AEP-NRC-2021-18
10 CFR 50.90

Docket No.: 50-316

Donald C. Cook Nuclear Plant Unit 2
Response to Request for Additional Information Regarding License Amendment Request for
One-Time Extension of the Containment Type A Leak Rate Testing Frequency

Response to Request for Additional Information Regarding Unit 2 Request for One-Time Extension of the Containment Type A Leak Rate Testing Frequency

Figure 1: Exposed Cadweld Rebar Splice

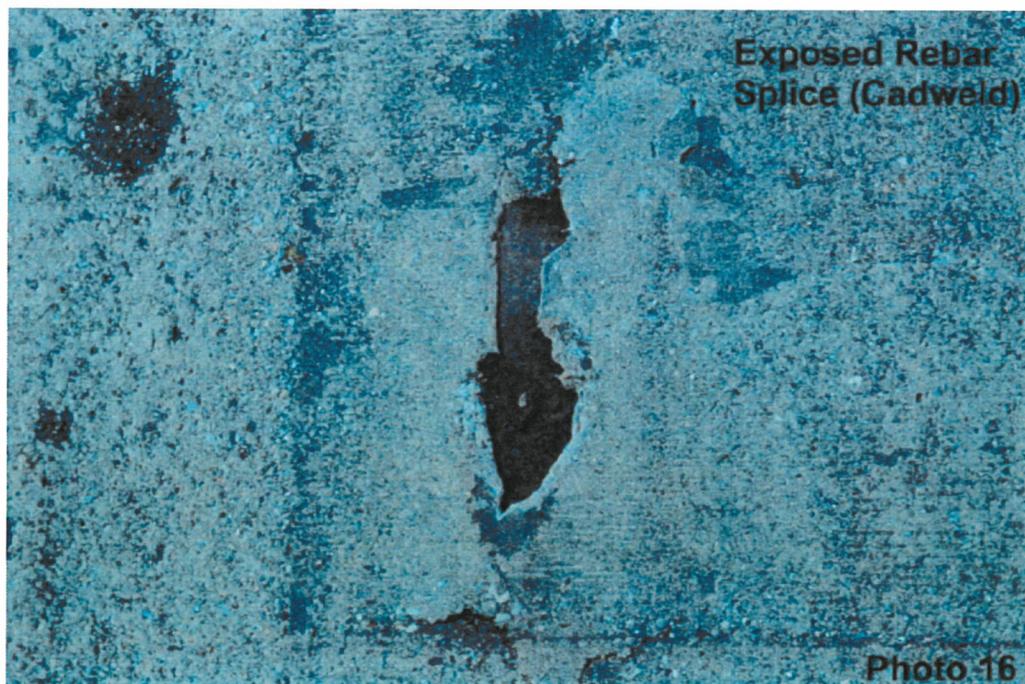
The minimum concrete cover thickness for rebar or mechanical rebar splice connectors is 1.5 inches, based on the American Concrete Institute (ACI) Code. If rebar is exposed as stated, the depth of concrete cracking would be at least 1.5 inches below the concrete surface. Concrete spalling or popout typically has an inverted cone shape (larger area on the concrete surface and smaller area near the rebar). Therefore, for a 45 degrees cone with its apex at the rebar, the surface area would be 7.07 square inches (3.1416 x 1.5 in x 1.5 in), not one square inch as stated. In addition to the

above inconsistency, the licensee's description that "the maximum depth of the spalling and popout identified was only 1 in. deep" is also inconsistent with the minimum concrete cover of 1.5 inches for rebar.

- To help resolve these inconsistencies, please describe the cause and the three-dimensional shape of the concrete spalling or popout from the concrete surface to the rebar below and how the repair was performed.

A photograph of the spall is included below as Figure 1. The spall depth to the surface of the rebar splice was estimated at 0.5 inch (") - 0.75". Since the diameter of the cadweld rebar splice is larger (approximately 3.75"), compared to the #18 rebar (approximately 2.25"), the cover provided to the rebar at this location is 1.25" to 1.5". The cause of the condition was that a previous repair in this area had deteriorated.

The identified condition was repaired in 2010. The repair process involved chipping the concrete from around the exposed rebar splice, allowing at least one inch of clearance all around, then providing 3" concrete cover over the exposed rebar splice, working the concrete to blend with the surrounding concrete with good trowel finish, to the extent possible.
